工程指示 / 要求簡箋(E.I.)

工程指示編號：EI / 9124 / 25 修改版次： A  
 工程編號： J - 858 工程名稱：將軍澳日出康城  
 工程項目：幕牆 第 10 次 補玻璃 5 件 (小業主單)  
 收件人：Maggie 發件人：Jason 日期：17/09/2025

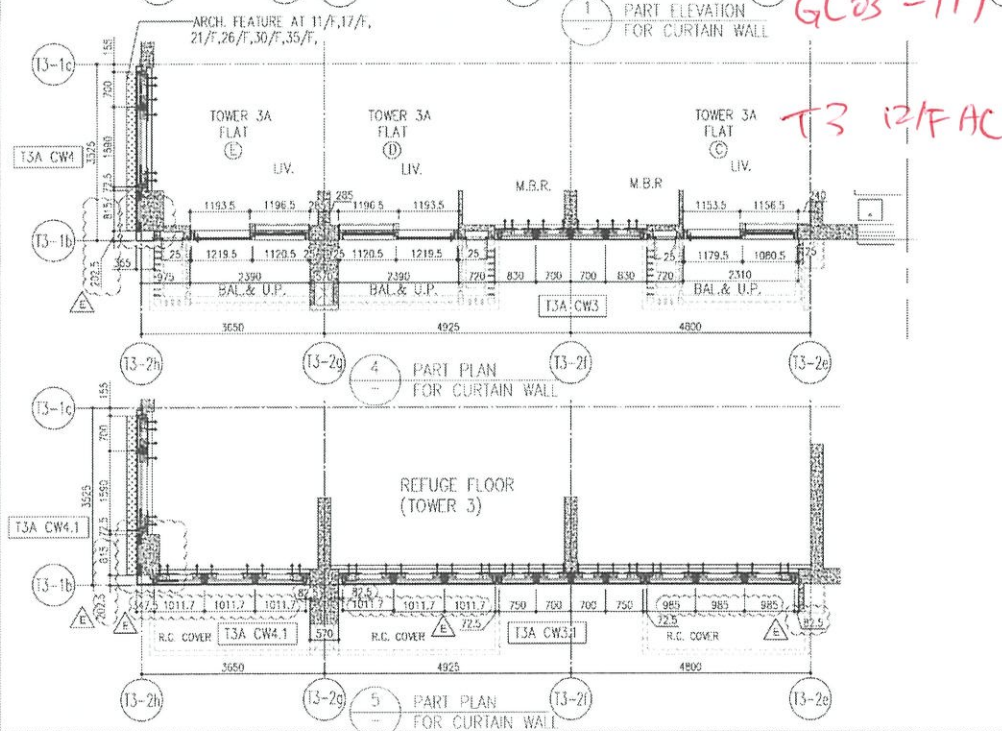
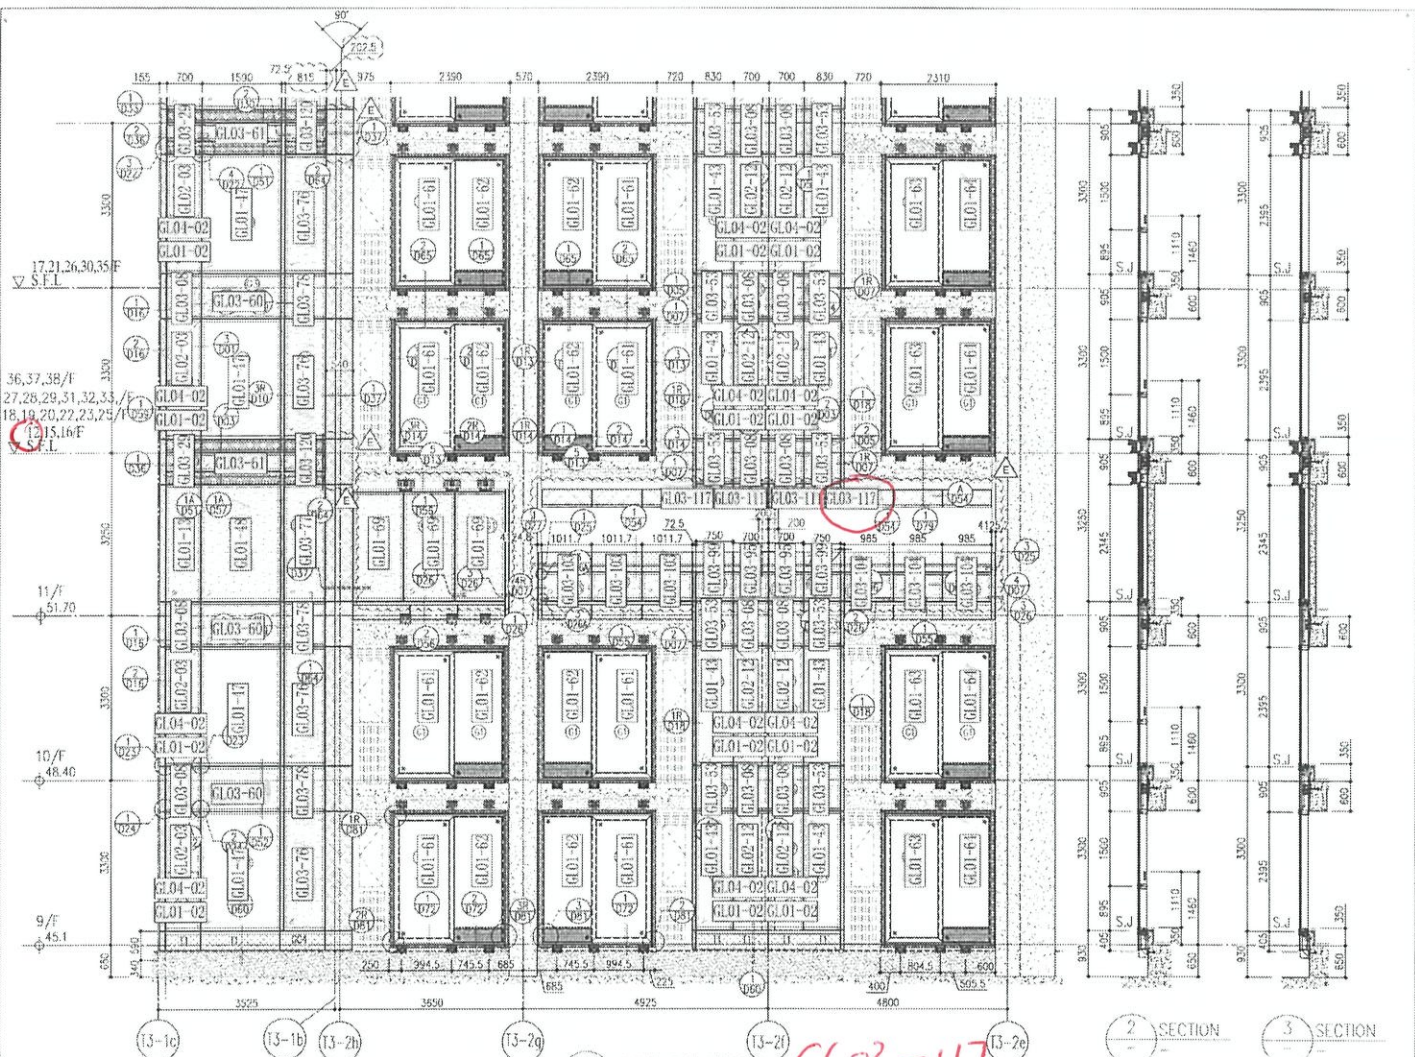
A 版本: 增加了 1 件玻璃 共 5 件

由於地盤需要更換玻璃，請按玻璃 BM 生產玻璃，共 4 件 送地盤。  
請安排熱浸

1. 不要印上熱浸標籤。只給”可移除”的標籤。
2. 依原 EI 4867, EI 4943, EI 4942 尺寸補，
3. \*\*\*\*\*玻璃標籤請註明座、樓層、單位。\*\*\*\*\* 請留意。
- 4.
- 5.
6. 地盆：更換幕牆玻璃，需用吊船。
7. 按芳姐 琮 資料
